M E M O R A N D U M

- TO* • Dublin San Ramon Services District • East Bay Municipal Utility District
Recycled Water Authority (DERWA)
- FROM* • Environmental Science Associates
- DATE* • May 19, 2003
- SUBJECT* • Discussion of Issues Raised in Comments on the Mitigated Negative
Declaration for the DERWA Tank R-200 Project
-

Figure 3
Reservoir Site - Plan View
of Proposed Facilities

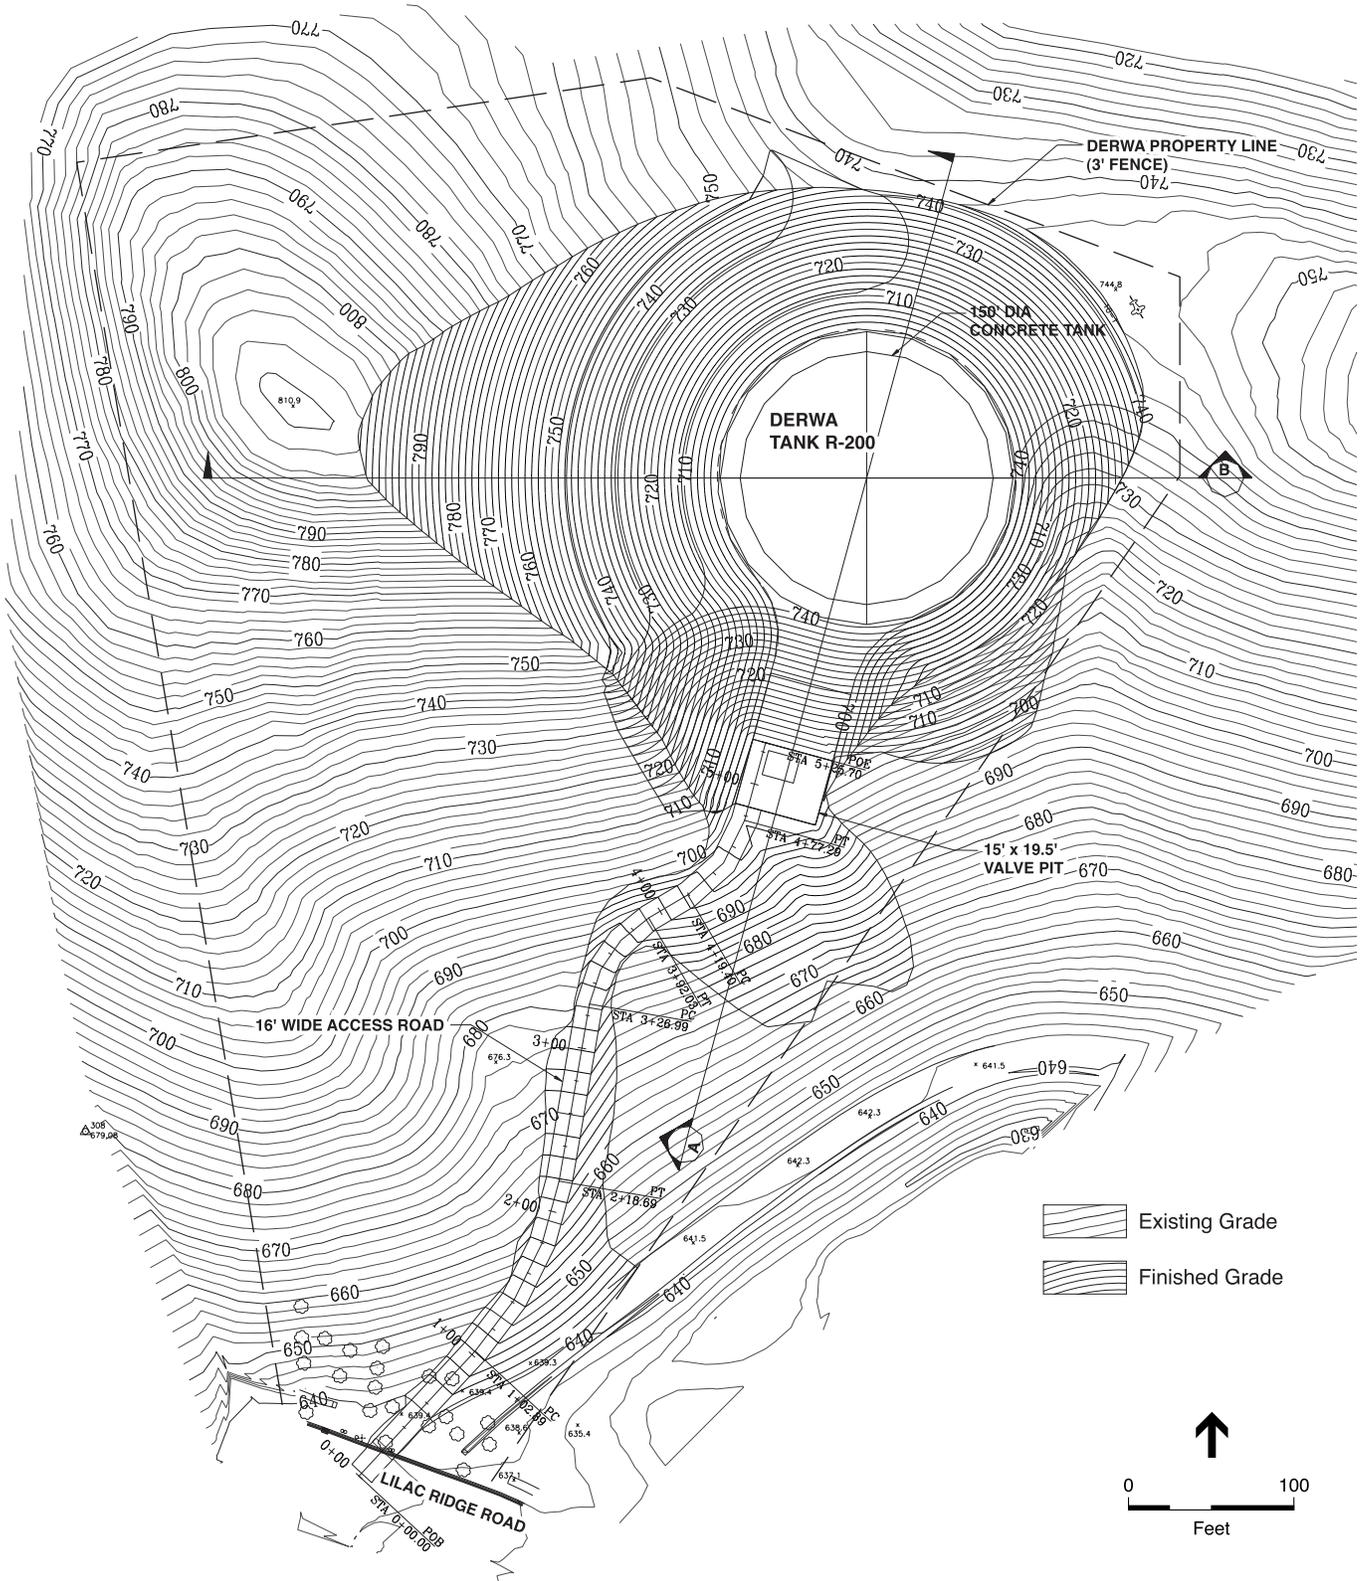
- *Page 1-6, paragraph two of project description, states that a three-foot high barbed wire fence would be installed around the property. Figure 3 shows the fence crossing the public trail easement. The fence should be adjusted to allow the public access to the trails. (Teri Rie, CCC Public Works Department)*

- *Figure 3 shows the reservoir site and its proximity to Lilac Ridge Road. Please provide another drawing depicting the reservoir site and the surrounding neighborhood and school sites. The requested drawing should provide more detail than Figures 2 and 5 with all roadways and schools within the vicinity clearly labeled. (City of San Ramon)*

- *The approved Gail Ranch Trail Exhibit dated August 12, 2002, ... shows a second trail beginning at Lilac Ridge Road heading northerly up to the top of the ridge. ... We would like DERWA to consider incorporating the proposed tank access road shown on Figure 3 into the trail system. ... (Teri Rie, CCC Public Works Department)*

Figure 5 shows all of the roadways in proximity to the project and they are clearly labeled. The scale is such that not all of the street names fit on the map, so numbers are used; the street names corresponding to the numbers are shown in Figure 1. Schools are shown with the standard symbol for a school site.

Pages 1-8 and 1-8, Figures 3 and 4 – change:

Since publication of the MND the grading plan has been refined somewhat, and the access road profile corrected. This change does not materially affect the analyses in the MND (e.g., excavation estimates would not change, nor would the visual simulations) The updated drawings are reprinted at the end of this memorandum.
